Access Compliance Report

Public Rights-of-Way

(Pedestrian Signals)

Intersection ID: N/A	Main Street:	Cross Street: N/A	Location: N/A
ADA ID: DC1EA7A0CB24	Signal Type: One Push Button-Non APS	Overall Compliance: No	Severity Score: BTN 1: N/A BTN 2: N/A No BTN: N/A
Codes/Mitigation Info/Possible Solution		Field Measurements/Component Compliance

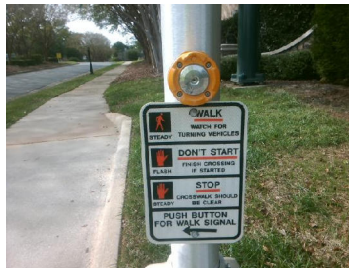
N/A	B 1 Clear Xing Direction?	N/A	N/A	B 2 Clear Xing Direction?	N/A
	B 1 Crossing Direction	To S		B 2 Crossing Direction	N/A
Yes	B 1 DistanceTo XWalk (in)	2.0	N/A	B 2 DistanceTo XWalk (in)	N/A
No	B 1 DistanceTo Curb (in)	140.0	N/A	B 2 DistanceTo Curb (in)	N/A
Yes	B 1 Diameter (in)	2.0	N/A	B 2 Diameter (in)	N/A

Possible Solutions: Replace Signal Push Button With APS Button on New Post. Remove & Relocate Sign.
